Technical Service Bulletin

GROUP	NUMBER
CAMPAIGN	14-01-057
DATE	MODEL
DECEMBER 2014	GENESIS SEDAN(DH)

SUBJECT: FOAM PAD ADDITION TO THE REAR COMBINATION LAMP (SERVICE CAMPAIGN TV7)

Description: This bulletin provides the procedure to add a foam pad to the rear combination lamp to improve sealing and prevent water intrusion/condensation.

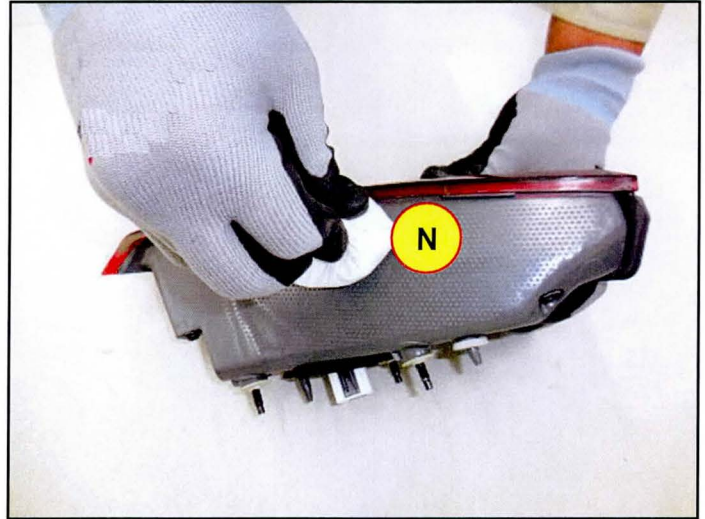
12. Clean the pad addition area (N) with a clean fabric.

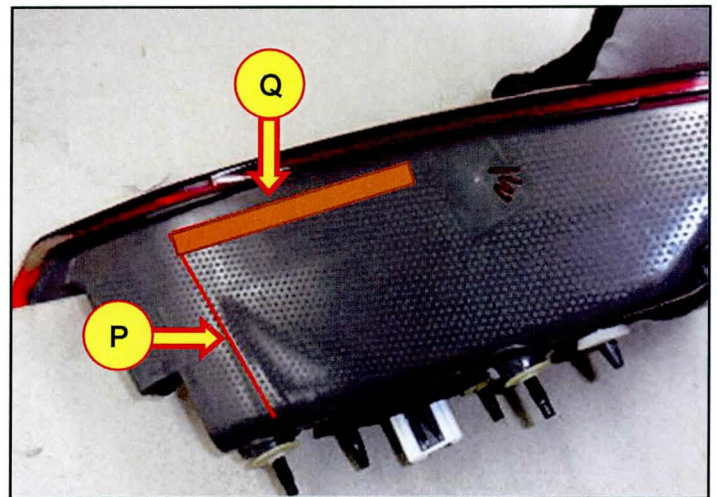
13. - P : Vertical end slope line
- Q : Horizontal end line of the embossment
- Orange rectangle area : Pad addition area

14. Attach the pad to the rear combination lamp for LH & RH and then reinstall all the removed parts in reverse order of removal.
